ADDENDUM No. 1

PROJECT NAME: **Tennis Upgrades at Tom C. Clark and Sandra Day O'Connor HS**

RFCSP# **2025-015**

DATE: 02/10/2025

SHEET
C-5.0

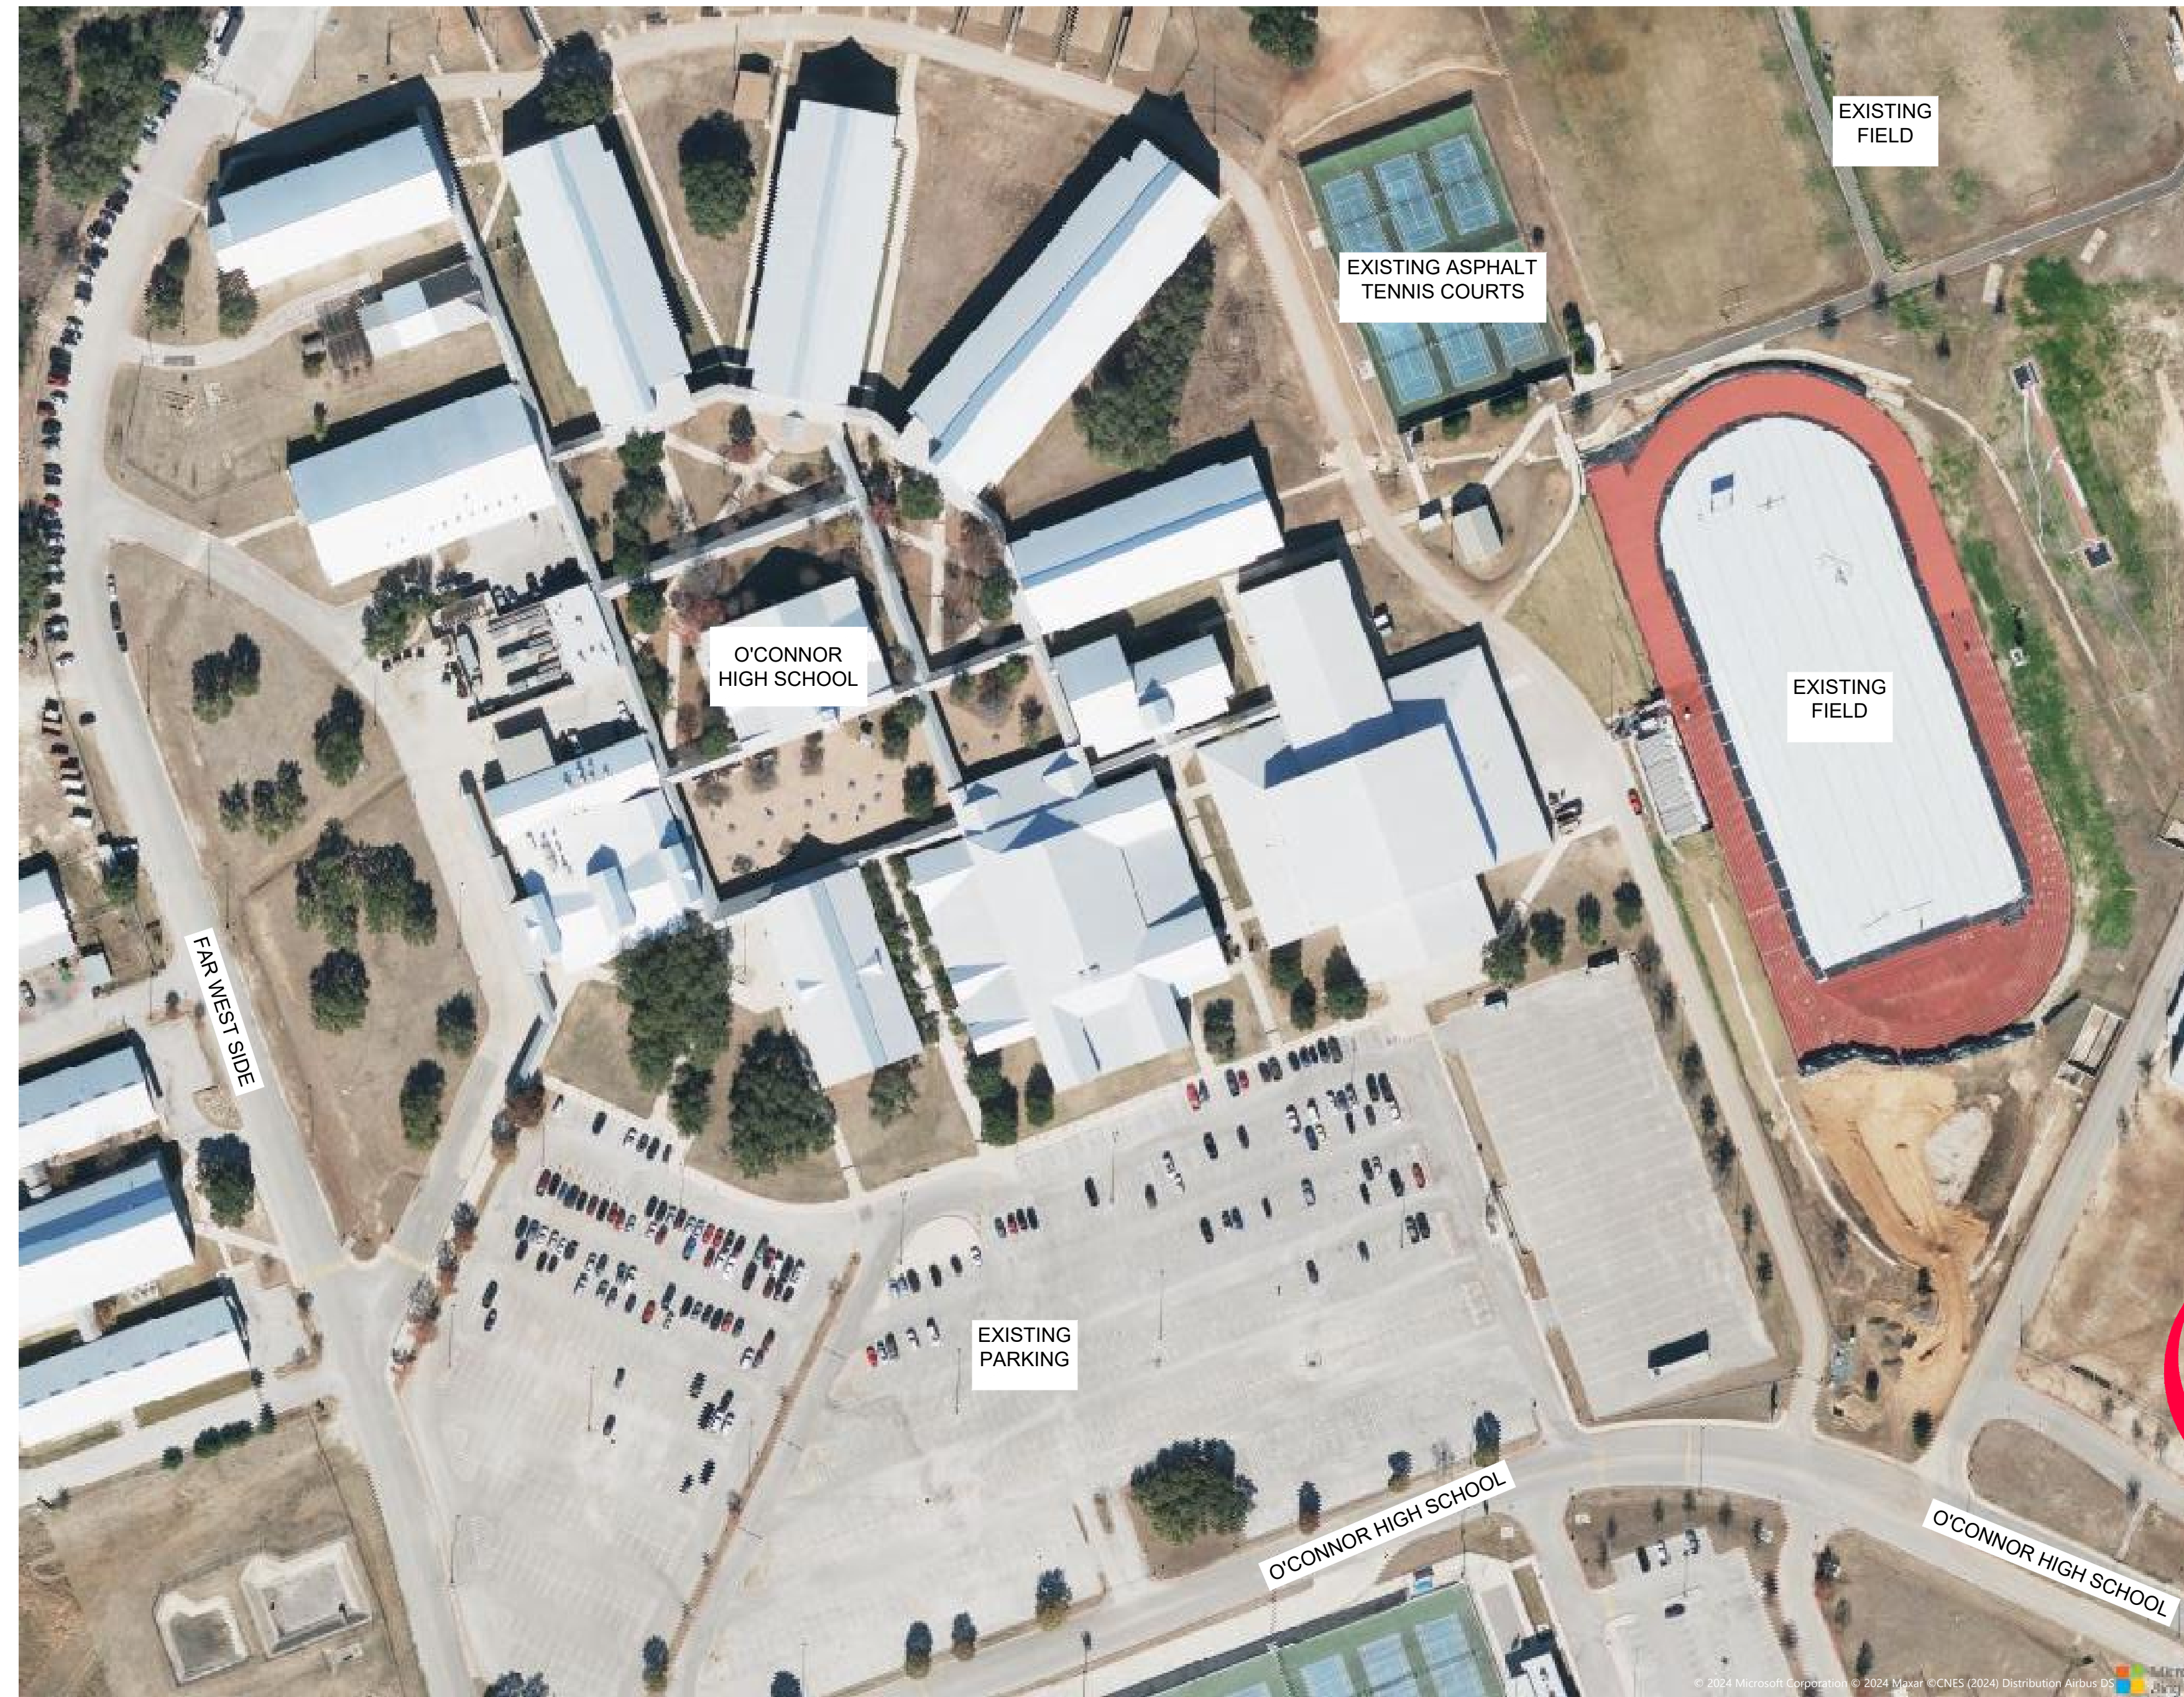
1. Site plan for O'Connor states that there is no water source for the campus? However, in past projects, a hose bib was located across th the drive.

Response: NISD permits the use of on-site water for construction purposes. However, if a hose bib is not available, it is the contractor's responsibility to provide the necessary water to complete their scope of work. See revised sheet C-5.0

- IF A HOSE BIB IS NOT FOUND ON-SITE, CONTRACTOR TO PROVIDE THEIR OWN WATER SOURCE FOR ANY STRIPPING OF EXISTING SURFACE OR ANY OTHER ACTIVITY THAT REQUIRES WATER. NISD WILL ALLOW THE USE FOR ON-SITE WATER IF HOSE BIB IS FOUND.
- PROGRESS AERIAL PHOTOS WILL BE REQUIRED, MONTHLY, BY THE CONTRACTOR ON THIS PROJECT.
